MATERIALS LICENSE

Licensee			
1. American Video Glass Company	3. License Number	37-30348-01	
2. 777 Technology Drive Mount Pleasant, Pennsylvania 15666-2717	4. Expiration Date	March 31, 2007	
	5. Docket or Reference No.	030-34274	
6. Byproduct, Source, and/or Special Nuclear Material	7. Chemical and/or Physical Form	8. Maximum Amount that Licensee May Possess at Any One Time Under This License	
A. Cobalt 60	A. Sealed sources (Nordion Model C-163)	A. Not to exceed 2.5 curies per source and 10 curies total	
9. Authorized use			
A. In Level Link, Inc. Model 770-A5 gauges.

Summary Sheet Of
Radiation License corrections

SOURCE ASSEMBLIES, SERIES TGSA 770 AND TGSA 7116

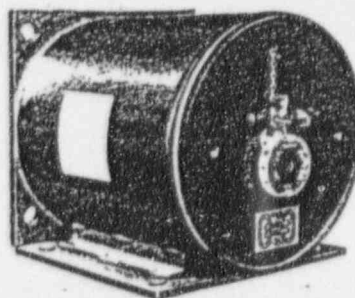
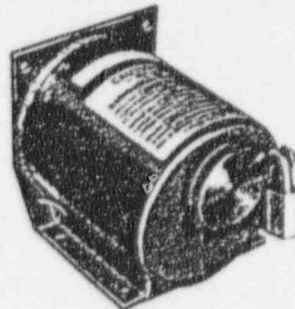
Ms. Dolce's comment: Must be able to close radioactive source quickly during an emergency in the event of an accident, fire or explosion. Please remove instruction on locking the source in the open position.

- A. Removed comment from vendor's literature about locking the source in the open position.
- B. The procedure change was reviewed with our process supervisor, both panel and funnel melting supervisors and radioactive safety officer, they all agreed.
- C. The following paragraph was added to section 9's written description.
 - * To facilitate quick closure of the source in the event of an accident, fire and explosion the source's shutter will be pined in the open position not locked. In case of an event the furnace operator or authorized personnel will be able to close the source immediately.

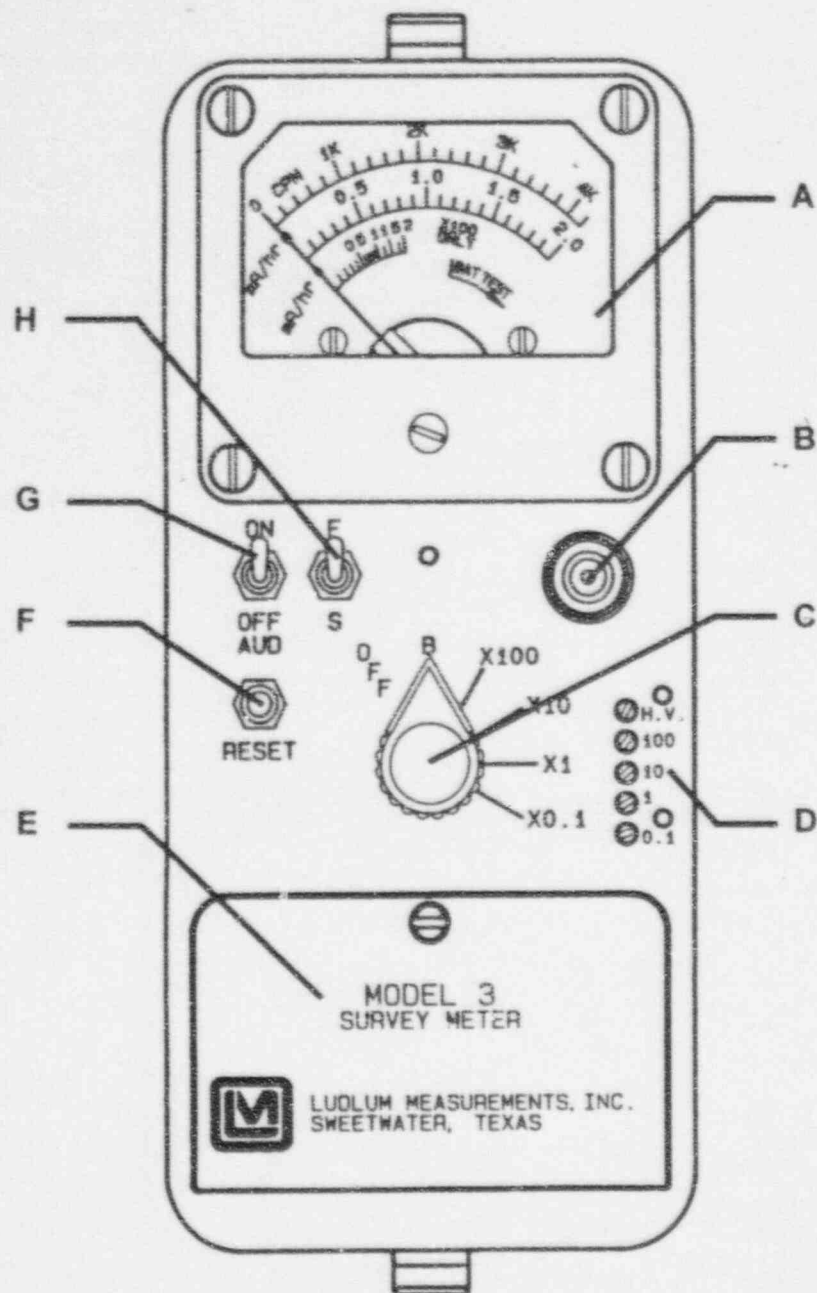
Ms. Dolce's comment: The survey meter's units of measurement are wrong they must be in mR/min. instead of counts per minute.

Corrective Action: A. To eliminate this problem I have switched to another unit that has the correct units of measurement. The unit is a Ludlum Model 3 survey meter and a model 44-2 gamma scintillator.
